PIC16F88X Family Silicon Errata and Data Sheet Clarification

The PIC16F88X family devices that you have received conform functionally to the current Device Data Sheet (DS41291F), except for the anomalies described in this document.

FIGURE 1: SCK PULSE VARIATION USING TIMER2/2

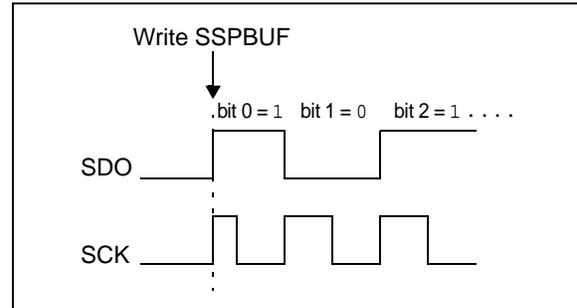
When the SPI is using Timer2/2 as the clock source, a shorter than expected SCK pulse may occur on the first bit of the transmitted/received data (Figure 1).

To avoid producing the short pulse, turn off Timer2 and clear the TMR2 register, load the SSPBUF with the data to transmit and then turn Timer2 back on. Refer to Example 1 for sample code.

FIGURE 3: ACTUAL (INCORRECT) OPERATION WITH CLOCK STRETCHING – EXAMPLE 1

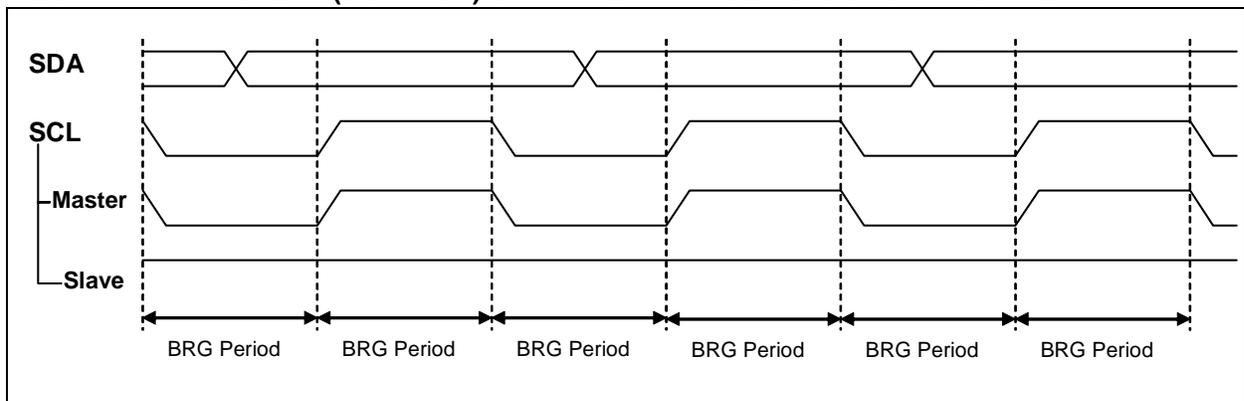
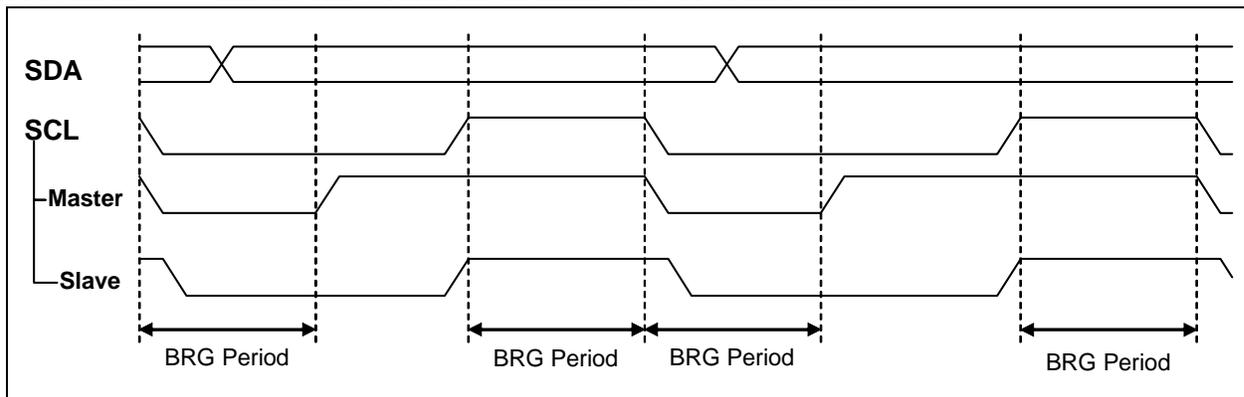
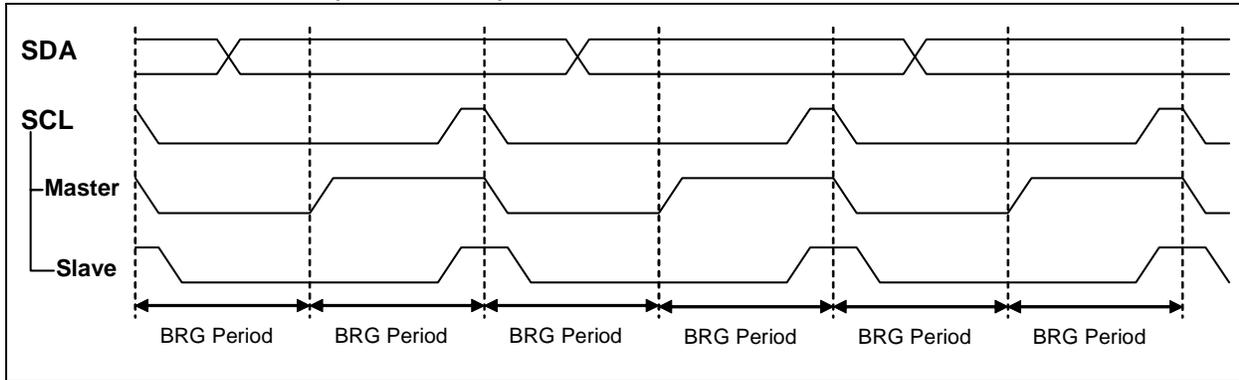
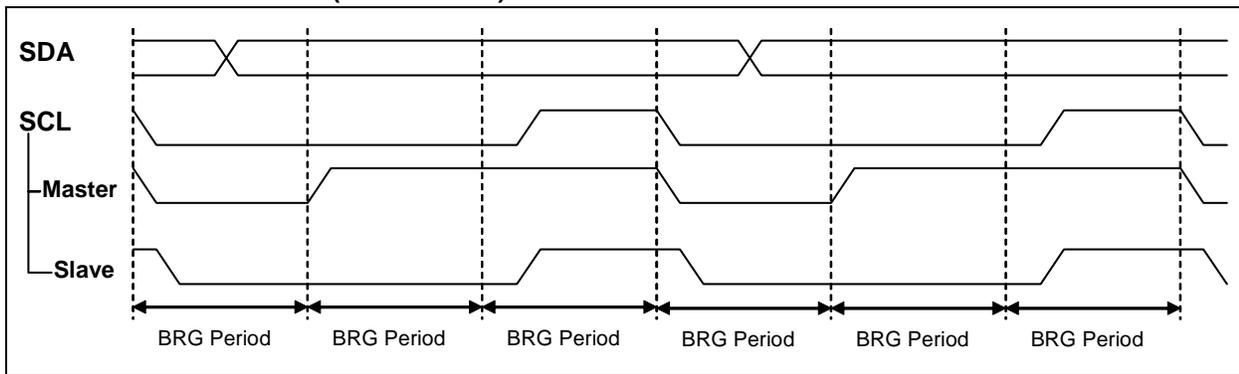
When the MSSP is I²C™ Master mode with a slave device stretching the clock, the clock generation does not function as described in the data sheet.

When a slave device is performing clock stretching by pulling the SCL line low, the master device should continuously sample the SCL line to determine when all slaves have released SCL. When SCL is released, the master device should wait one BRG period to ensure a constant SCL high time.

The current implementation does not ensure accurate SCL high time. During clock stretch, the MSSP device will erroneously continue running the BRG counter. At the end of the clock stretch the BRG counter continues to count down for the remainder of the BRG period, and then the MSSP device will immediately resume transmitting the data.

Figure 1 illustrates an expected I²C transmission in which the SCL line is completely controlled by the master device and the slave device does not attempt to stretch the clock period.

Figure 2 illustrates the expected operation of an I²C transmission in which the slave device has stretched the clock period by holding the SCL line low. The high time of the SCL pulse is constant, regardless of the duration of the clock stretch.

Figure 3 and Figure 4 illustrate an actual I²C transmission in which the slave has stretched the clock period by holding the SCL line low. Note that the high time of the SCL signal has shortened from the expected time.

Set the communication speed to match the slowest device on the bus. This ensures that no slave device will perform clock stretching.

It is possible to dynamically adjust the communication speed to match the device being addressed by modifying the BRG register. However, the behavior of slower slave devices must be understood and speed adjustments made such that no slave performs clock stretching.
